**Section 12A Application No.Y/I-DB/3
For Optimising Land Uses at Area 10b, Discovery Bay
Response to Comments**

Section 12A Application No.Y/I-DB/3 for Optimisation of Land Uses at Area 10b, Discovery Bay

Applicant's response to the departmental comments made available by District Planning Office on 23 and 28 December 2016, 5, 12 and 17 January 2017

Figure 8 Layout of OZP Compliant Scheme

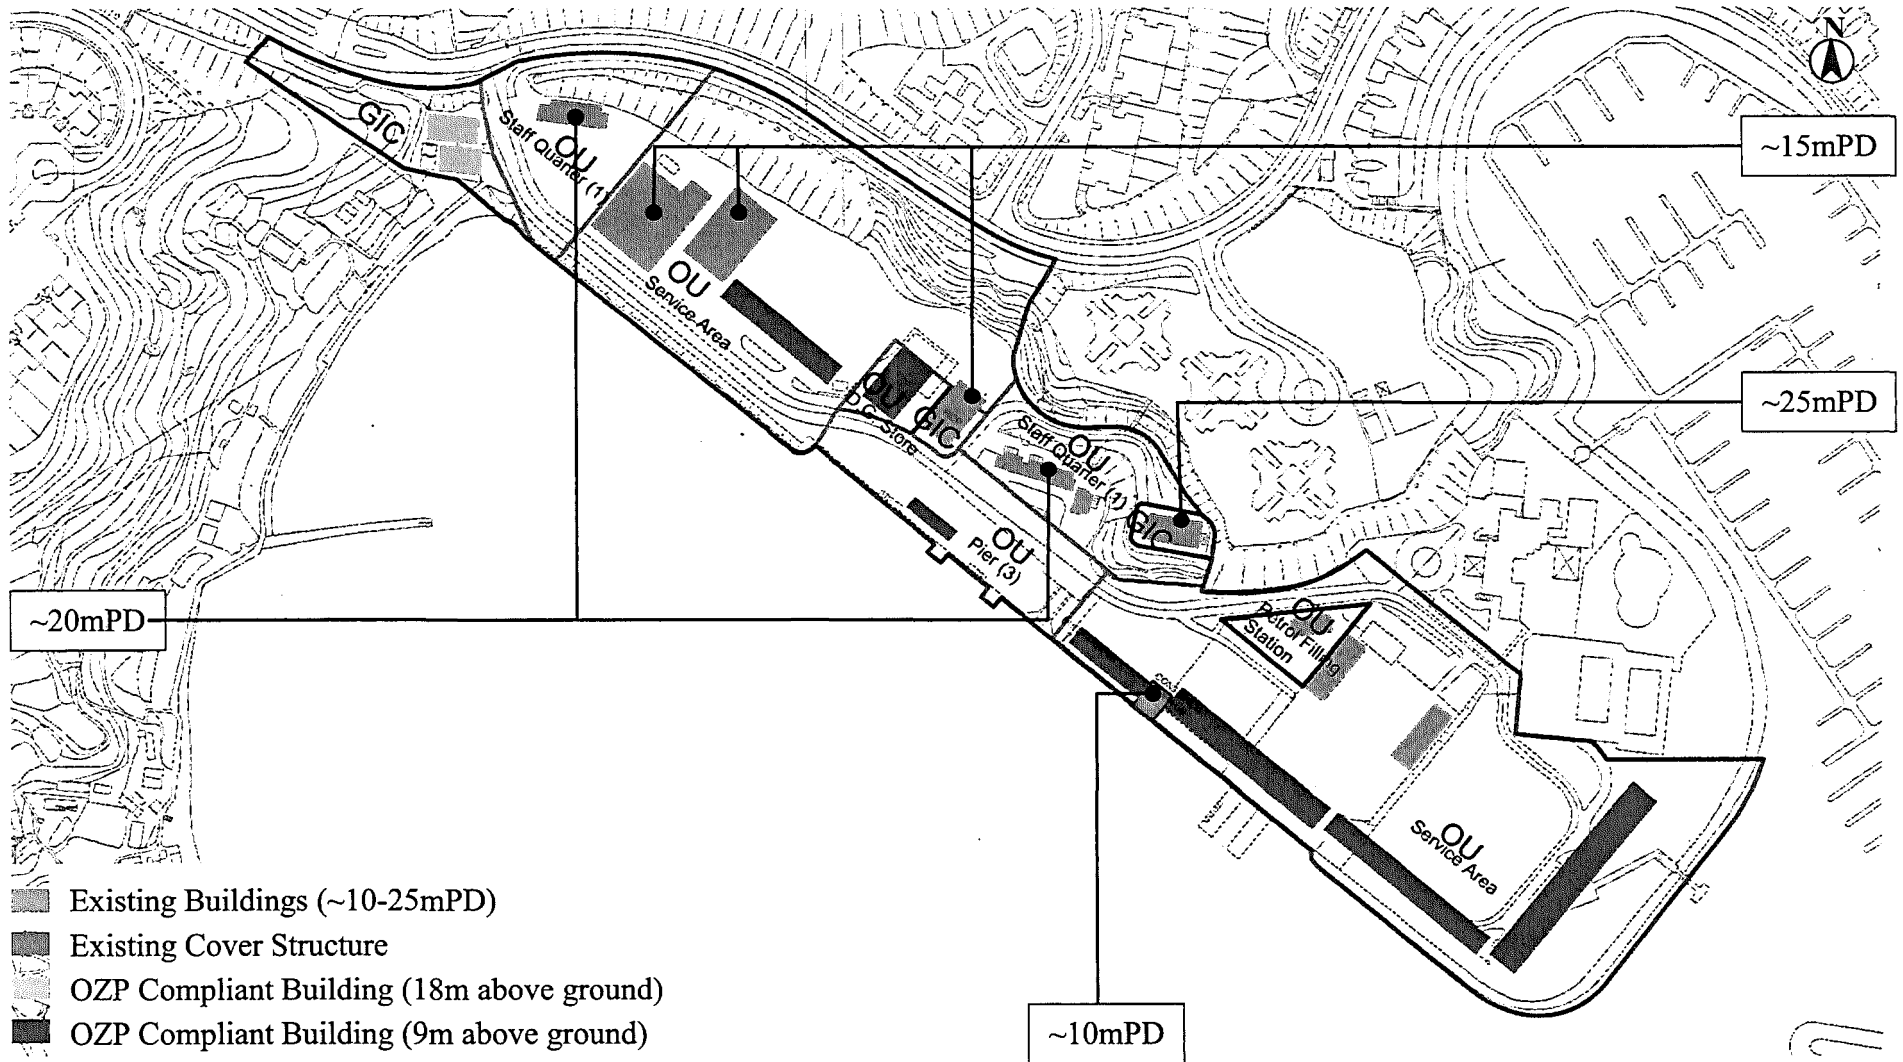
- "The detailed 3D model **Baseline OZP Compliant Scheme** is shown in Section 3.2.2."
- Figures 8, 18 to 24 – There are no particular comment on the proposed OZP Compliant Buildings as the proposed building height do not exceed the building height restrictions under individual zones in the Notes of the OZP. However, it is noted that some of the existing buildings are either missed out in the figure or their demarcations are not reflected properly. Some of the zoning boundaries are also not tally with the OZP as well. The applicant should review and rectify accordingly. Moreover, we are not able to verify the existing building height (~10-25mPD) as shown on the legend.

Noted. The boundary of the zoning is revised to tally with OZP. The existing building has been checked the building height has been listed in details. Please note that this OZP-Compliant Scheme was formulated by combining OZP-Compliant Buildings and existing buildings. Figure 8 and Appendix A has been updated. Some of the existing buildings are replaced with OZP-Compliant Buildings.

Figure 9 Layout of Baseline Scheme

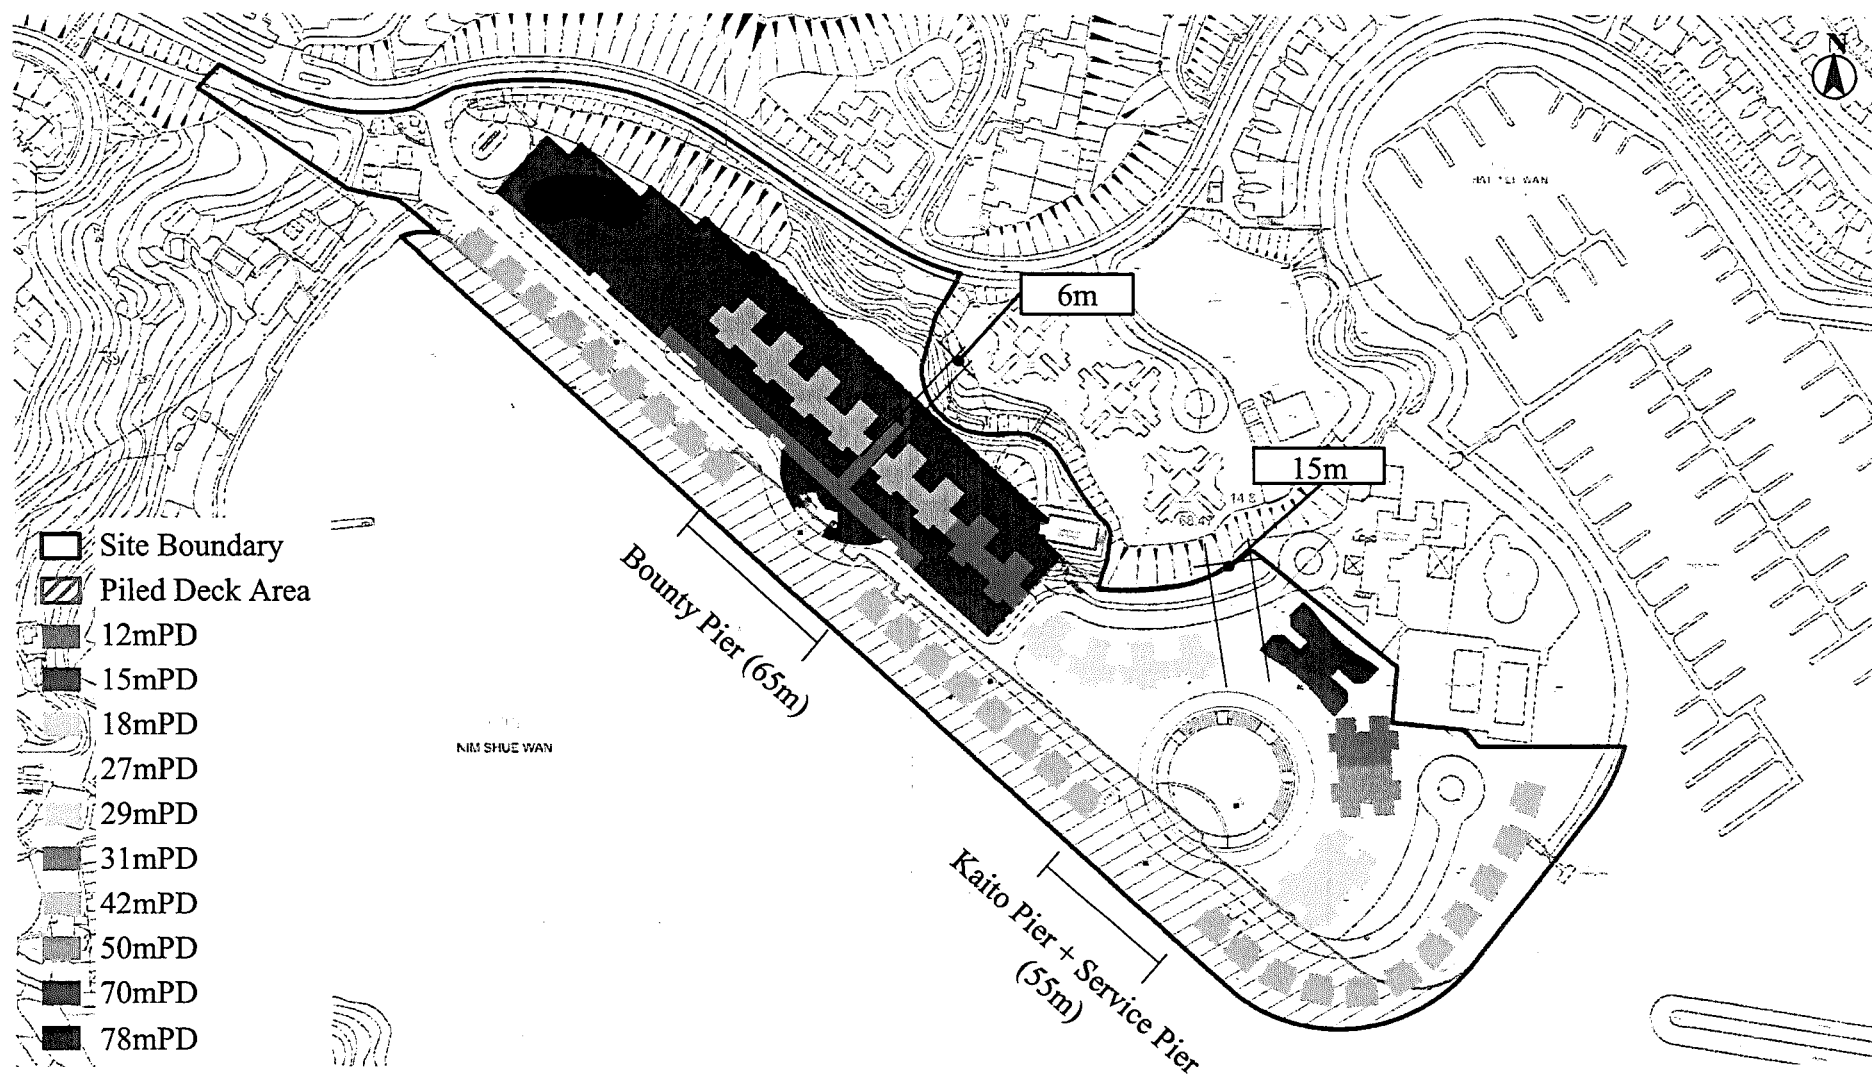
- Most of the building height reported in text does not tally with that shown in Figure 9. The consultant should clarify and revise as appropriate.
- Figure 7 – The consultant should provide a sectional drawing for illustrating the design details (e.g. building height) of the proposed terraced podium.

4. Figure 9 – The consultant should name two piers (i.e. Bounty Pier and Kaito Pier) on plan.

Noted. The building height in Figure 9 is correct. Text in Section 2.3.2 has been revised.

4. Noted. Indication of two piers has been added on plan in Figure 9.
